**Re: Union Gas Limited (“Union”)
2016 Sudbury Replacement Project
Board File # EB-2016-0122**

REQUEST TO VARY

Project Name: 2016 Sudbury Replacement Project

Request to Vary: 2

EB-2016-0122
Request to Vary 2
Schedule 1

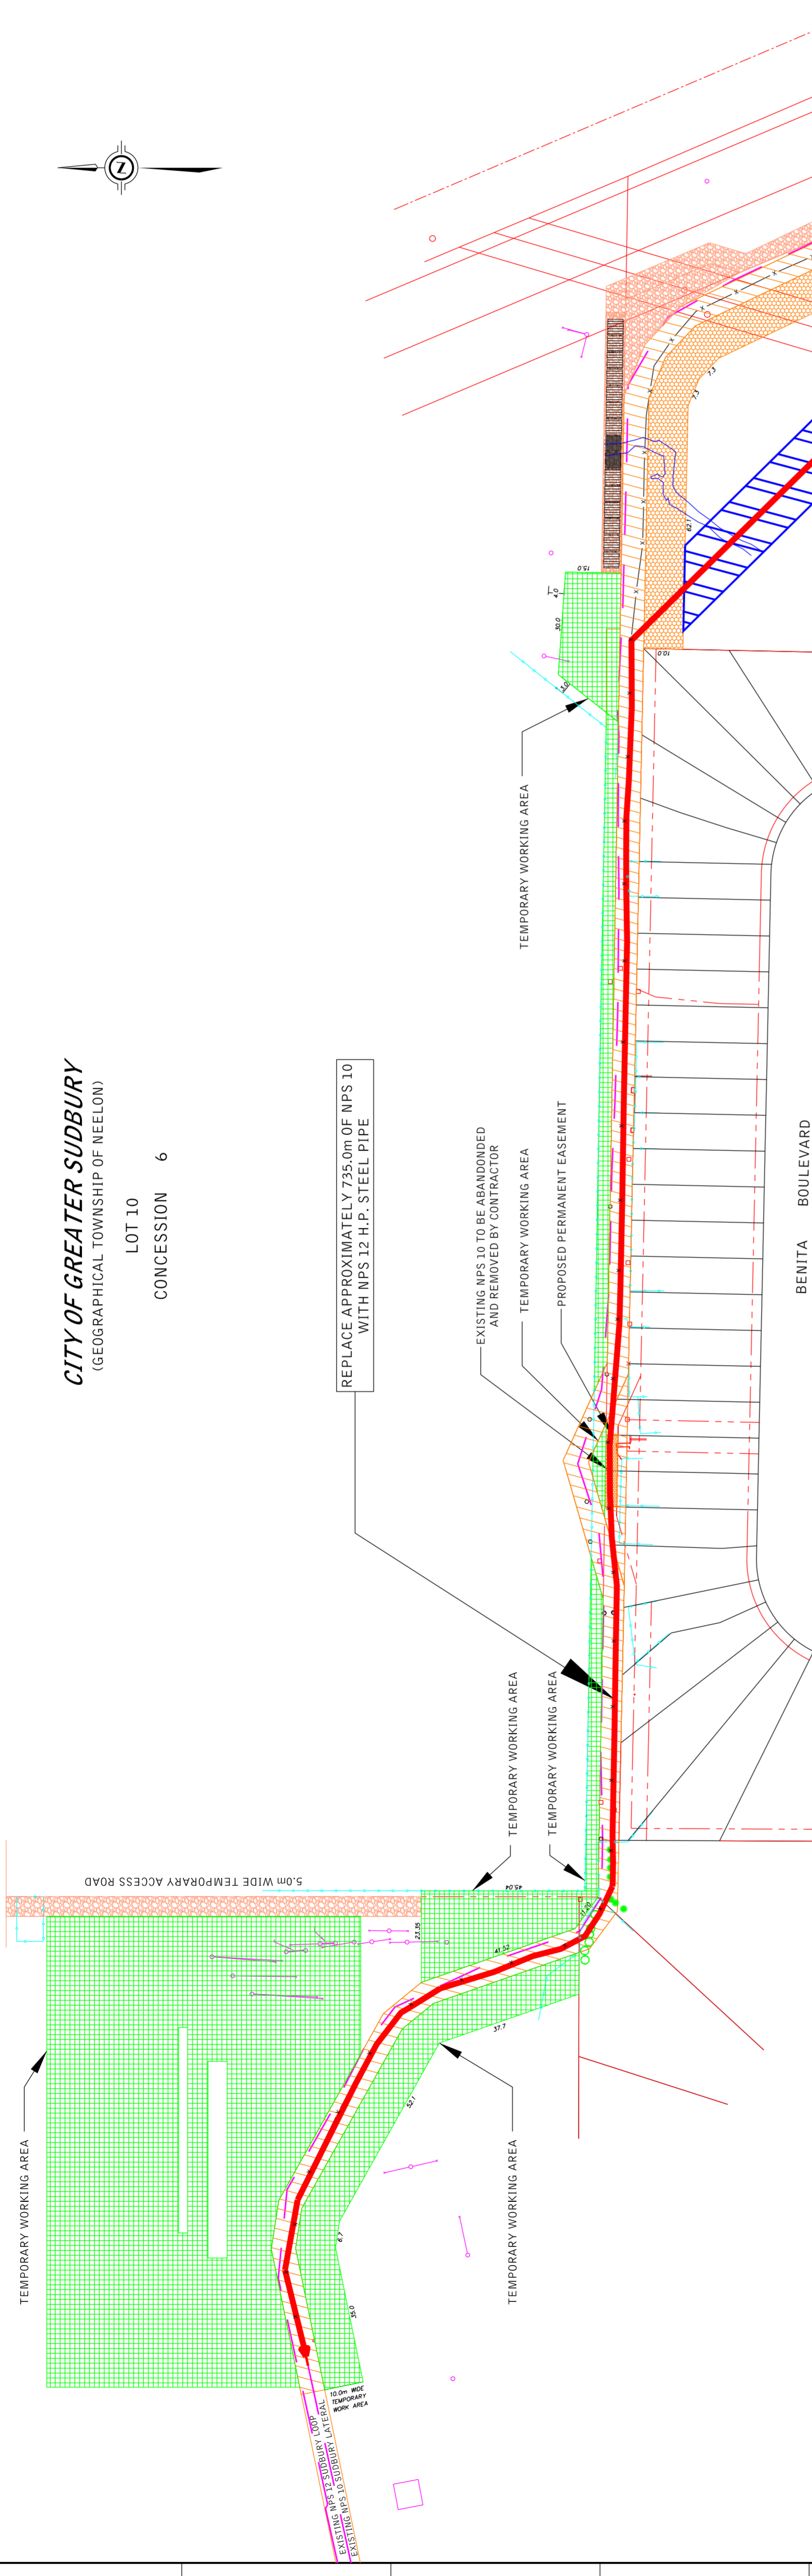
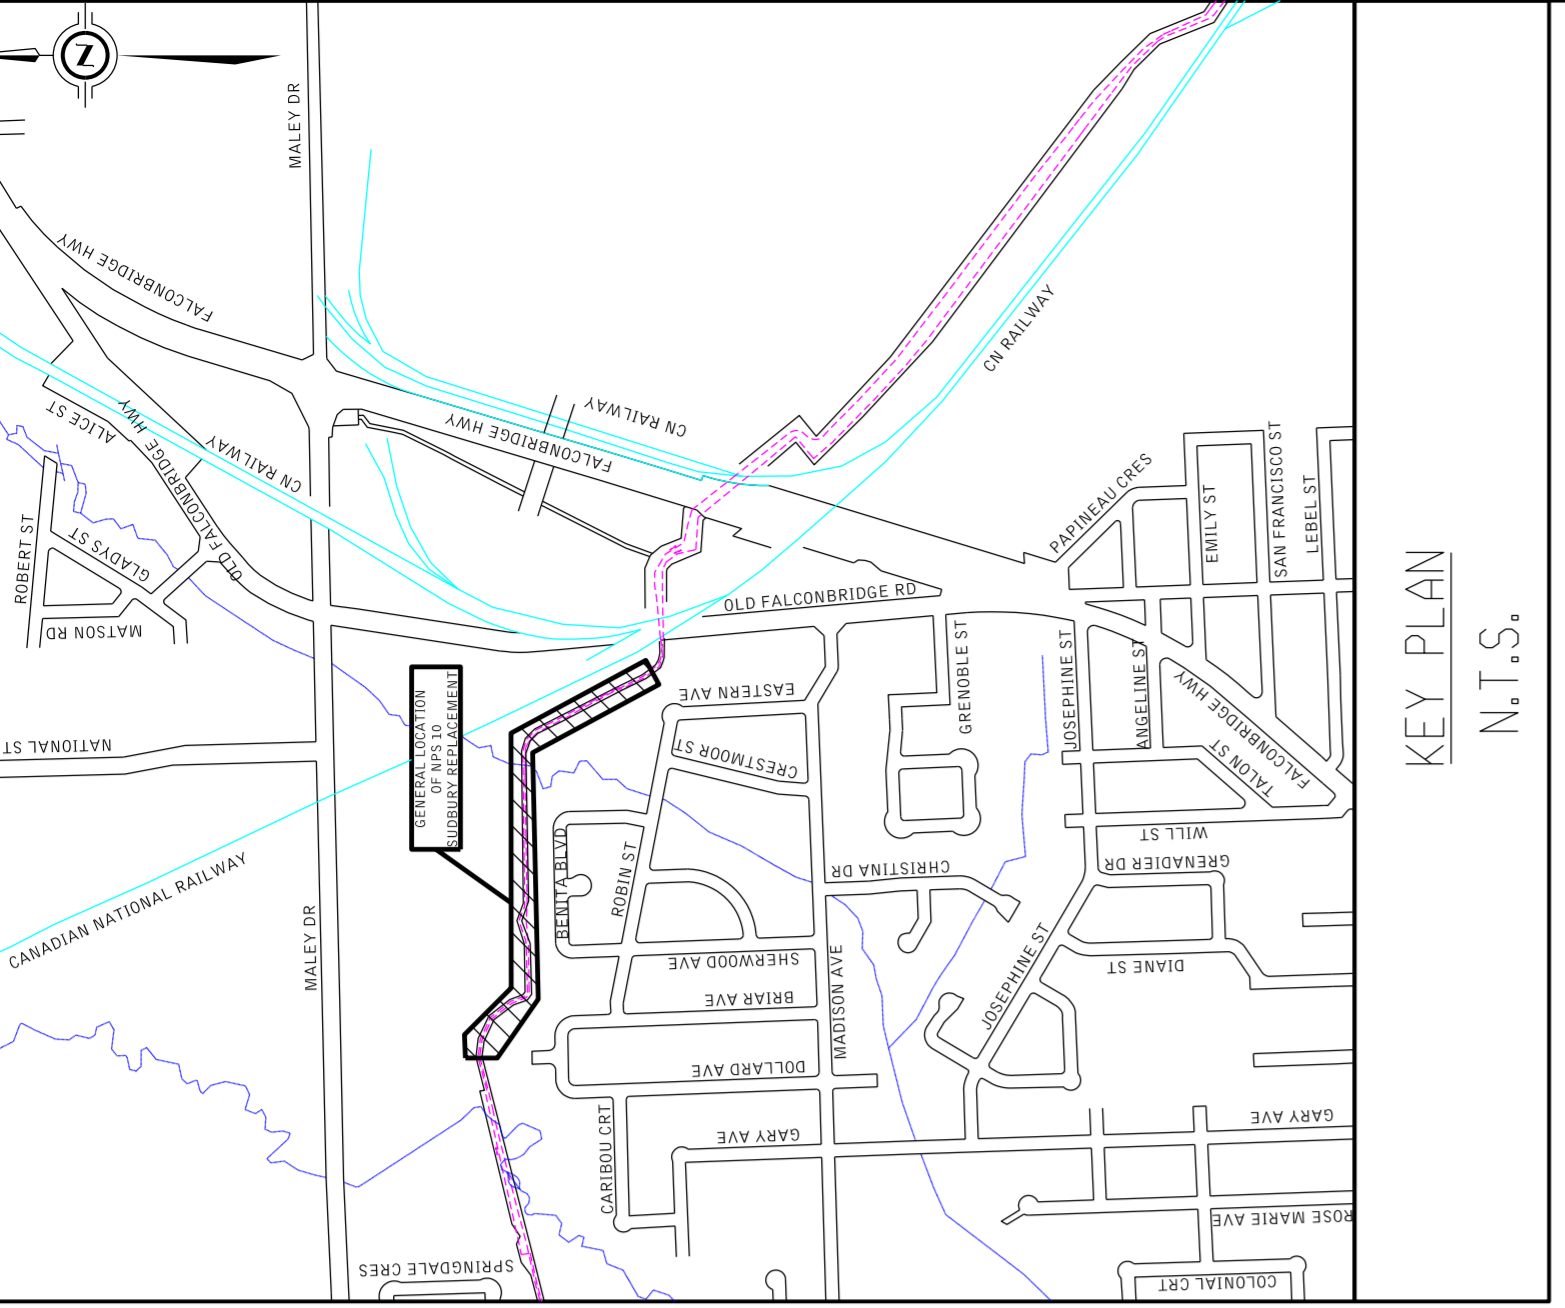
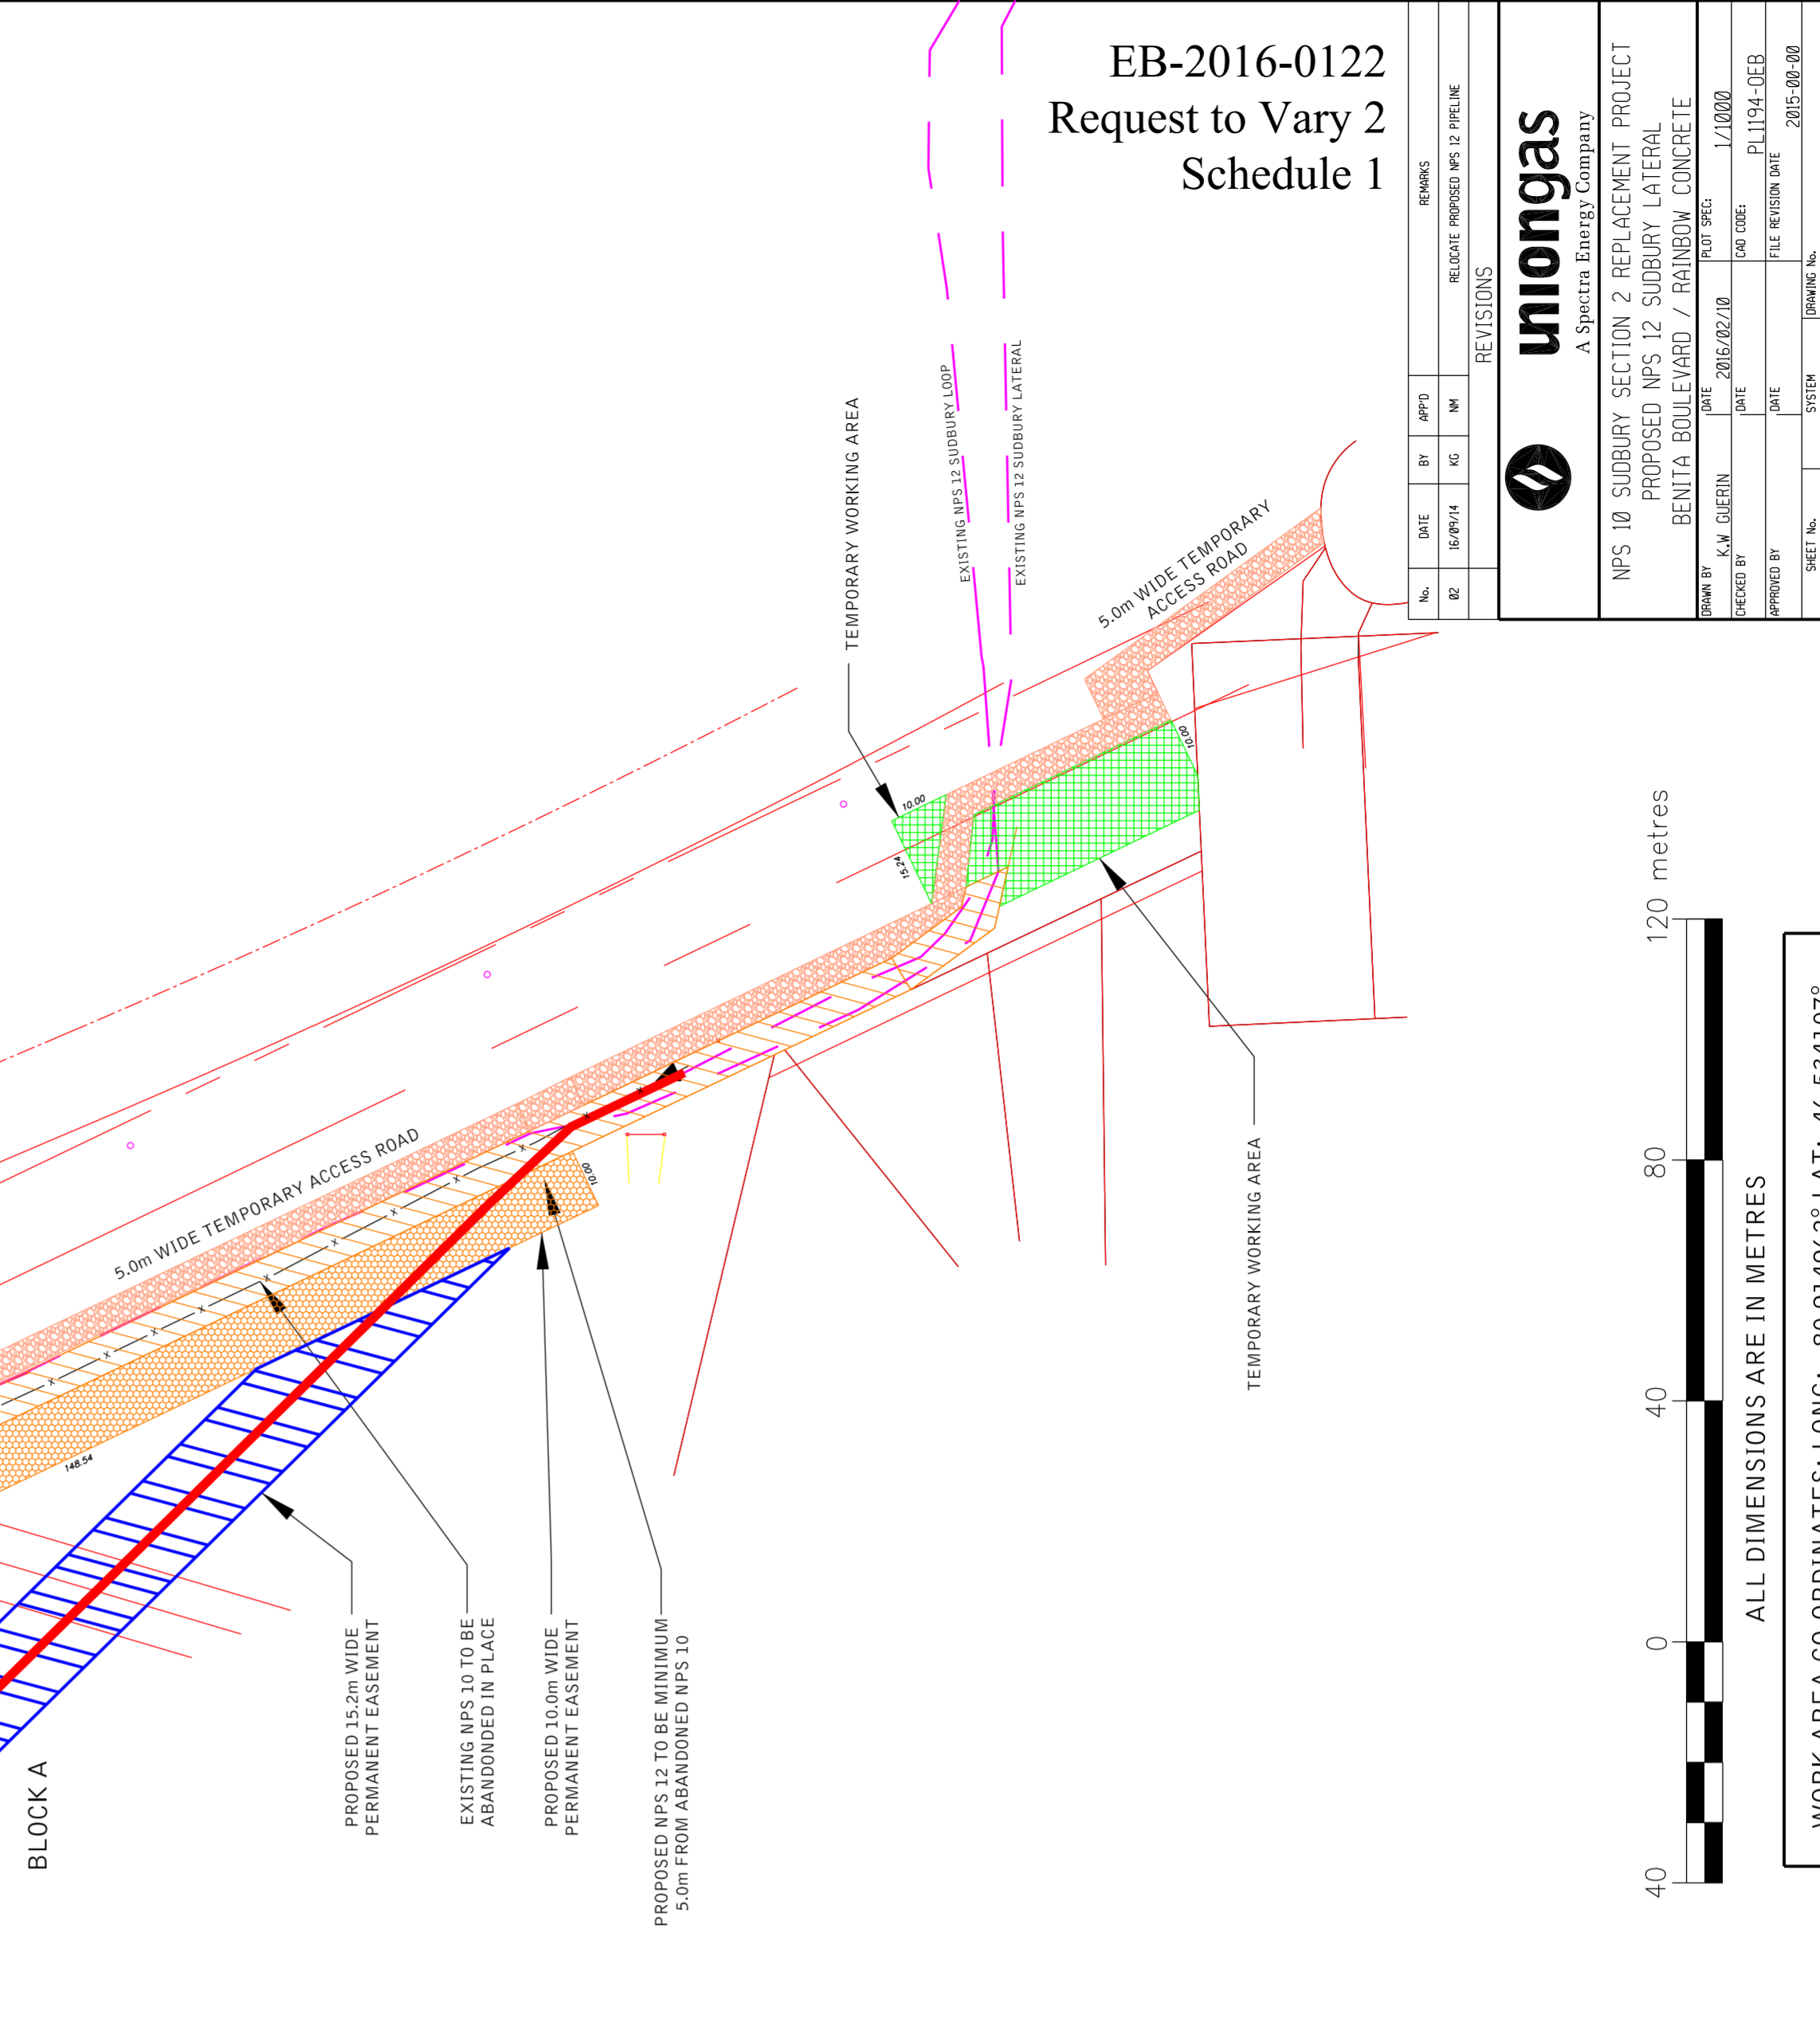
In order to facilitate more efficient construction of the Proposed Facilities in the area of Junction Creek Union is proposing a minor change to the route of the proposed pipeline on the City of Greater Sudbury property at the eastern end of Section One.

Union had originally planned to open-cut and drill this section of pipeline. Union's current proposal is to directionally drill the entire area where the route will be changed.

Additional permanent land rights are required for this change. Union has met with the City of Greater Sudbury who have not identified any issues with this proposed change.

NO.	DATE	BY	APP'D	REMARKS
R2				RELOCATE PROPOSED NPS 12 PRELINE
